ADDENDUM NO. 3

**TO THE PLANS AND BID DOCUMENTS FOR THE UNIT 4 PHASE 2
COMPOSITE LINER CONSTRUCTION PROJECT
AT THE MID-VALLEY SANITARY LANDFILL
in Rialto, California**

January 26, 2026

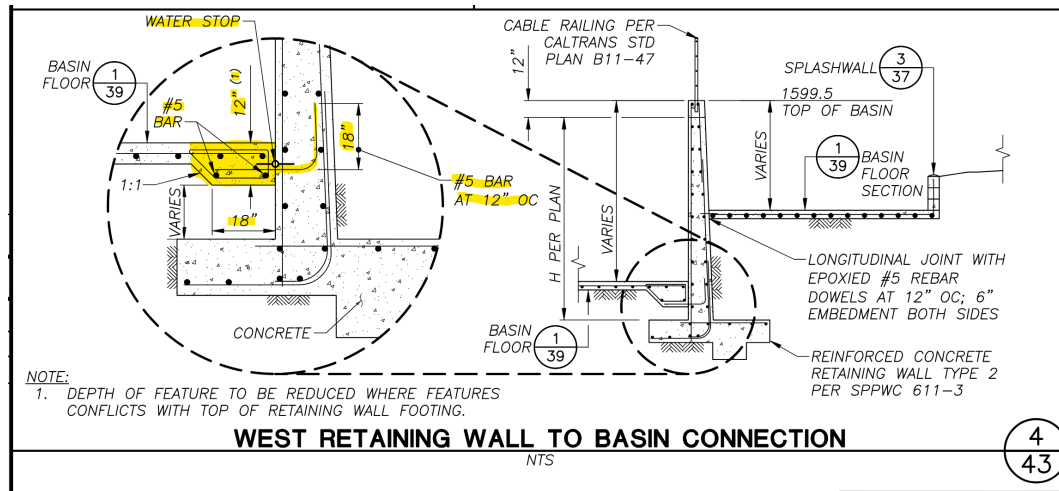
Q25. Sheet 40, Detail 7 references the concrete spillway. Please clarify how this work is to be paid, as no corresponding bid item is identified in the contract documents.

A25. Basin Spillway "Notch" shall be paid in Bid Item 98. The 2' x 12' spillway notch is to be formed into the retaining wall from station 11+17.47 to station 11+29.47 per Detail 5 on sheet 43.

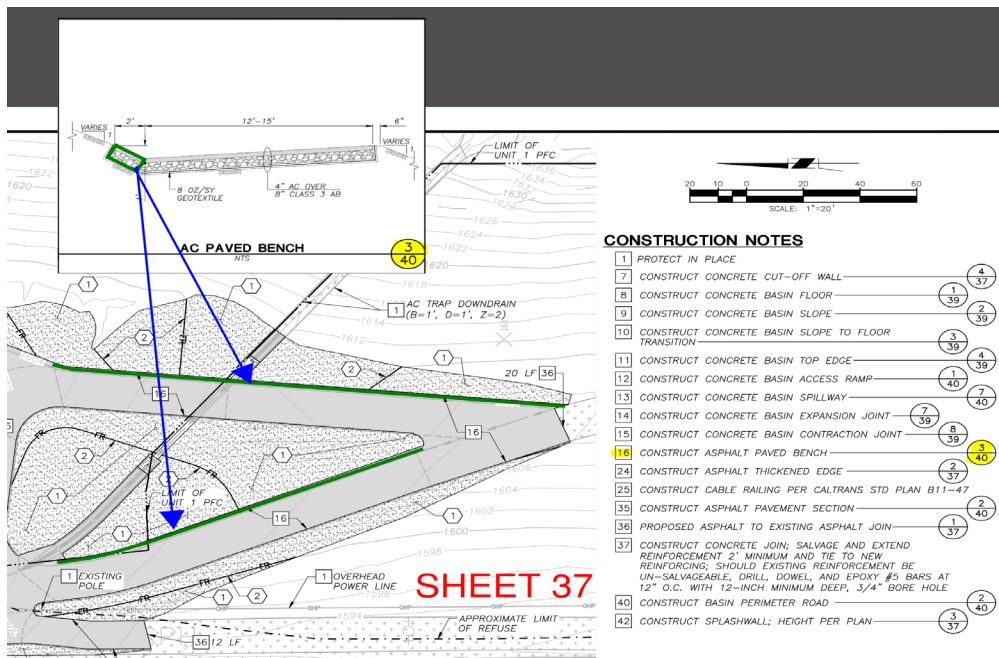
Q30. Note 4 on the project plans calls out an existing gas line to be removed/salvaged along the entrance facility entrance on Plan Sheets 20 and 21. Where is this removal to be paid? Also, Sheet 20 calls for the gas line along the north shoulder of the entrance to be removed, but there are no callouts on Sheet 21 of the project plans for that same gas line to be removed.

A30. The contract lump sum price paid for the subject demolition and removal is per Bid Item 52 Clearing, Grubbing, and Demolition – Entrance Facility Area and as described in the Technical Specifications Section 2C Clearing, Grubbing, and Demolition subsection 4 Measurement and Payment, Item 4.2.

MID-VALLEY SANITARY LANDFILL
 UNIT 4 PHASE 2 COMPOSITE LINER
 CONSTRUCTION PROJECT
 ENTRANCE FACILITY IMPROVEMENTS EAST

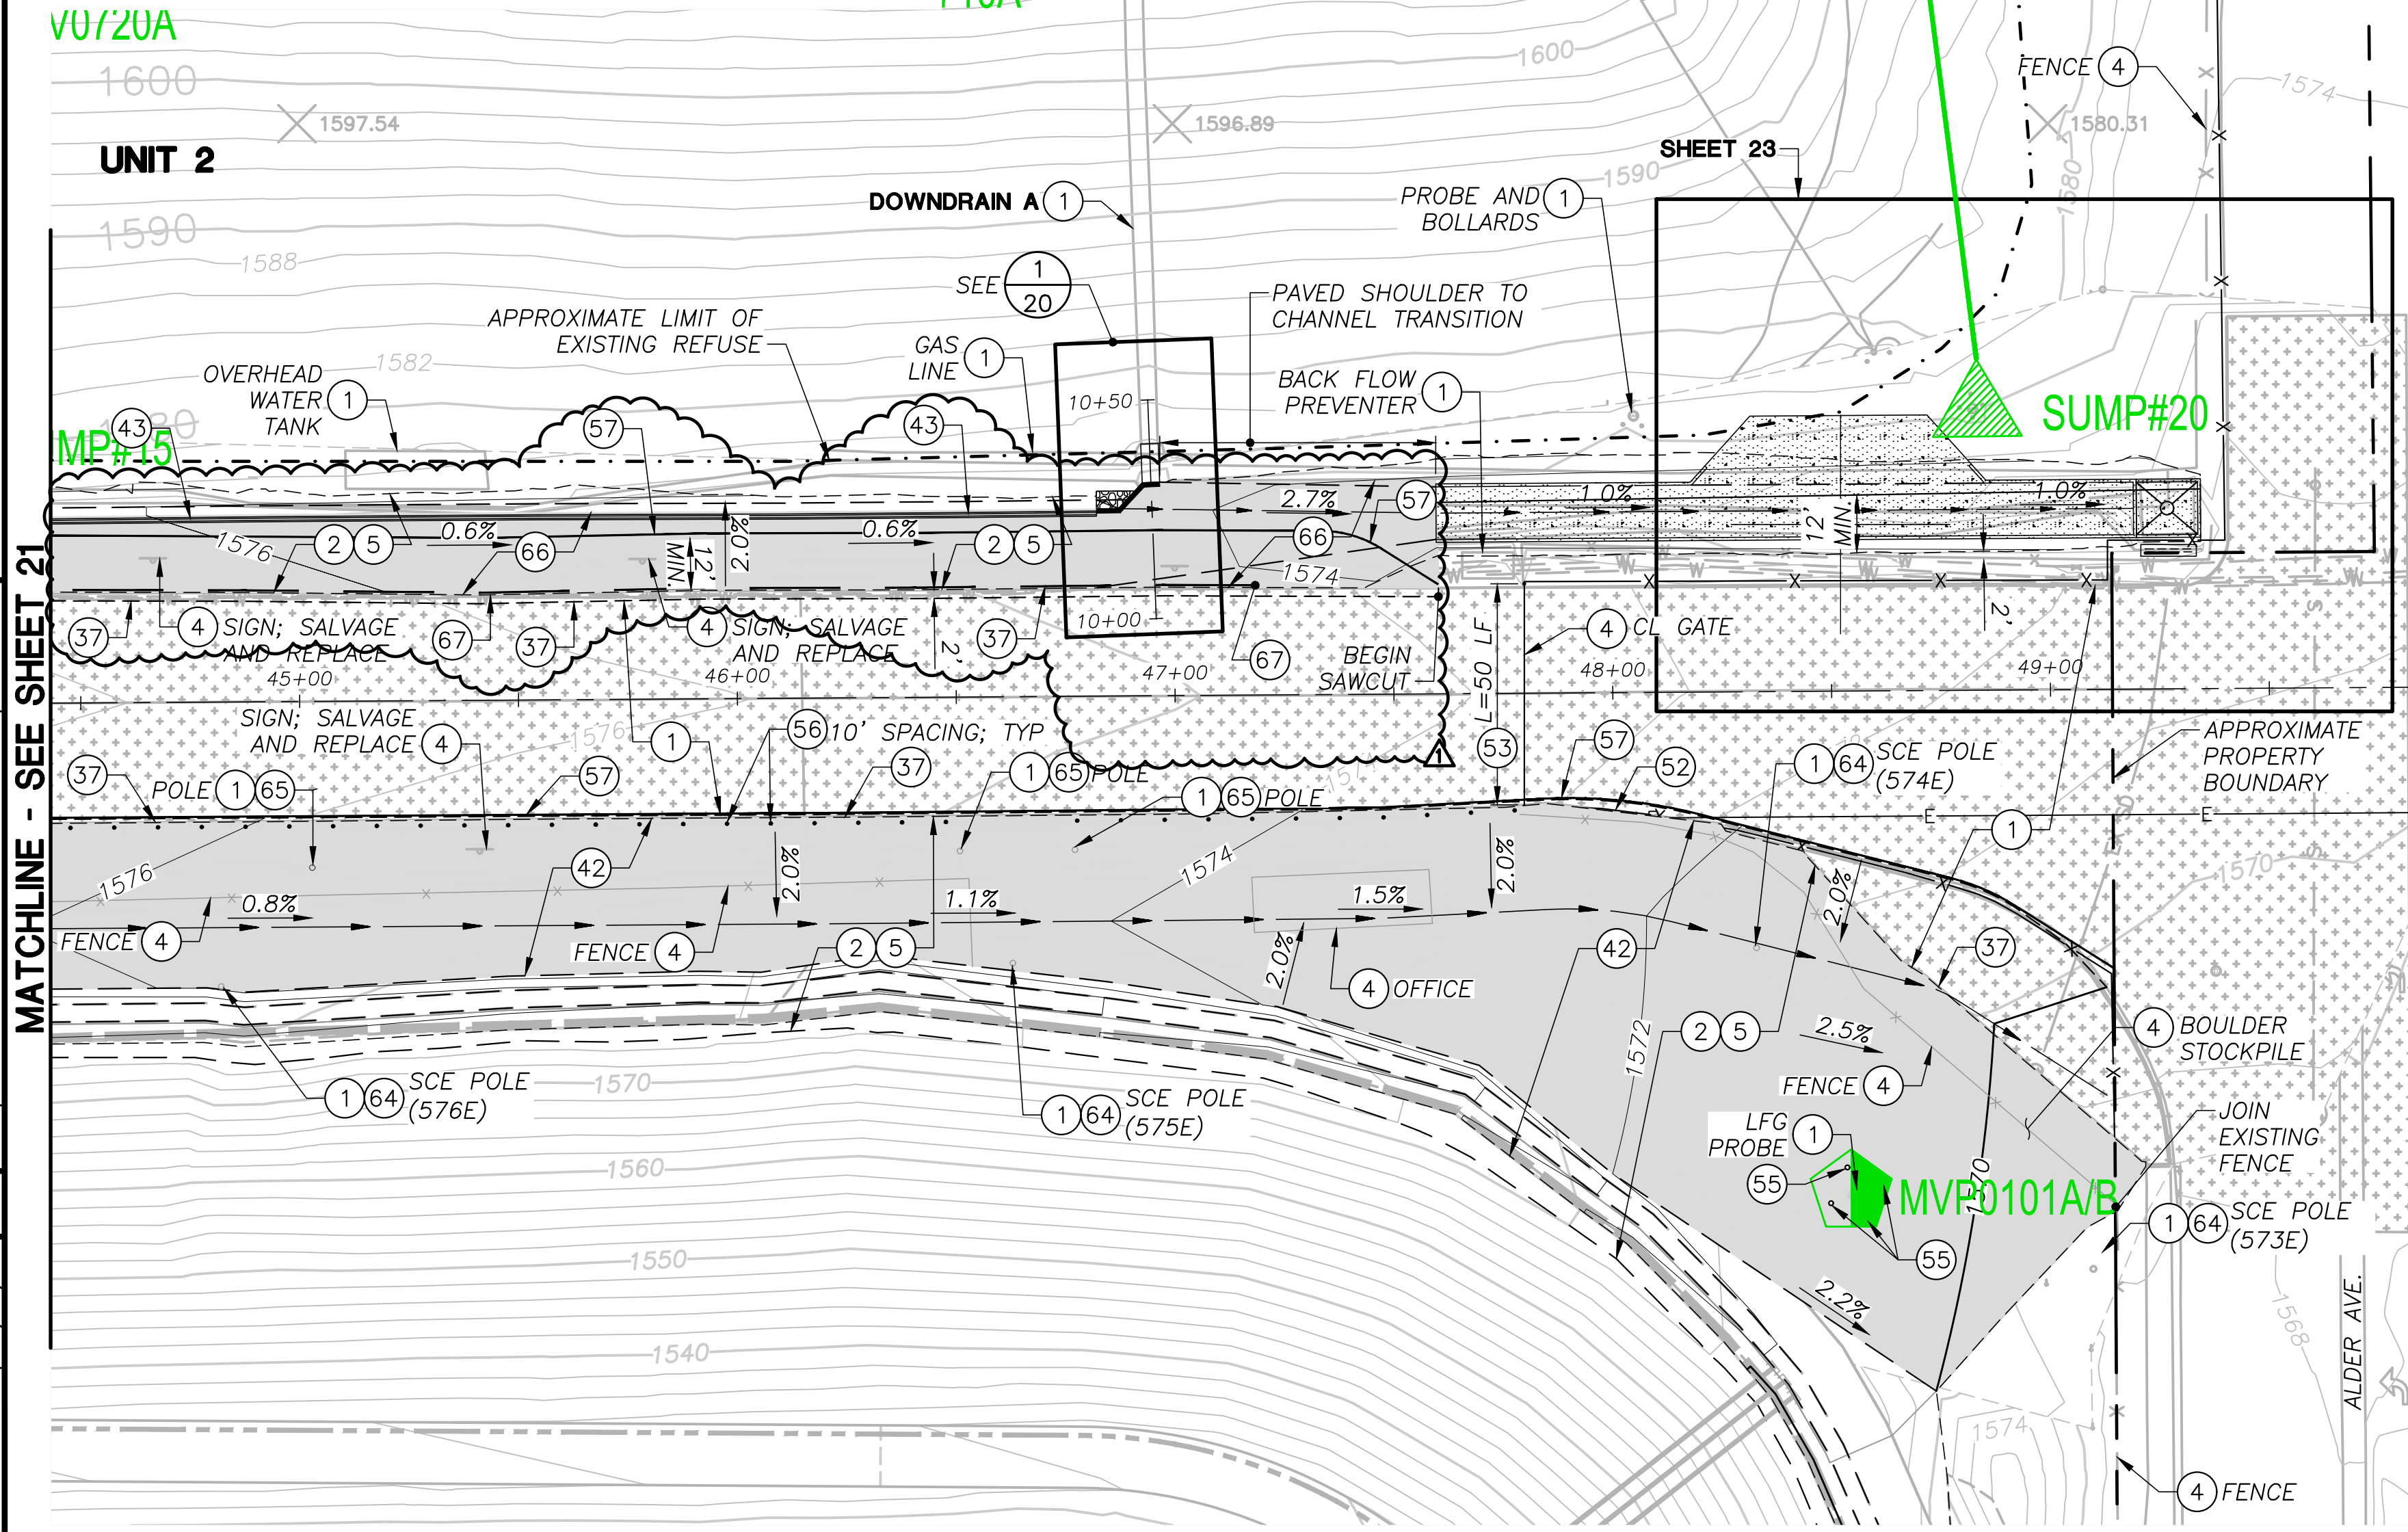
Q6. Reference Bid Item 57 and Plan Sheet 20 (note 42) please clarify if the asphalt to be installed in the front entrance should be 6" thick as indicated in the schedule of values or 4" thick as shown on the plans.

A16. Striping improvements are shown on reissued Sheets 20 and 21 as well as details on reissued Sheet 28. Striping is attributed to Construction Notes 57, 67, 70 and 71 on these reissued sheets. The Technical Specifications for Bid Item 60

A6. The asphalt pavement at the front entrance shall be constructed at a thickness of 4"AC over 8" CMB, revised from the previously indicated thickness of 6"AC, in accordance with reissued Sheet 20 and modifications to reissued Section 2K, Subsection 4.8, Shoulder Paving, with Addendum No. 3.
